Modification of slit holder (part
21-021) to include three screws for
holding the slit in place.

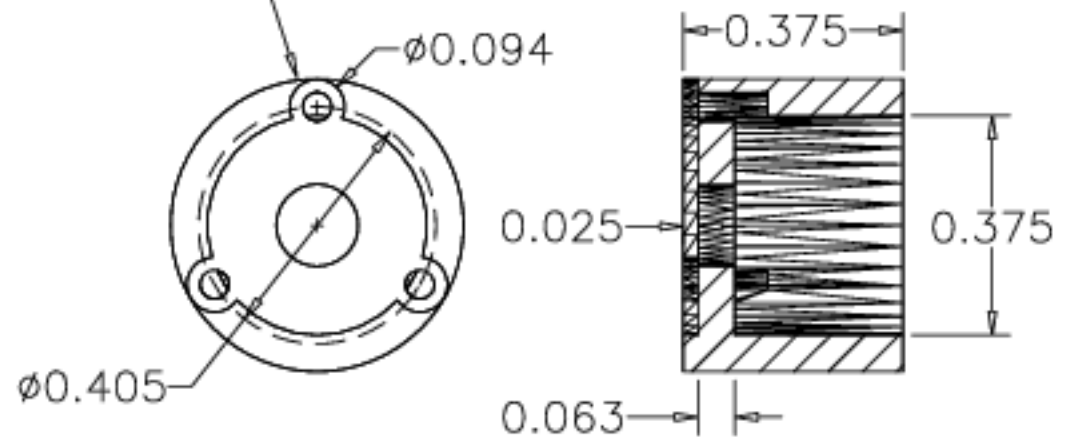
Three holes tapped for
0-80 (or smaller)
screws counterbored to
level of indentation
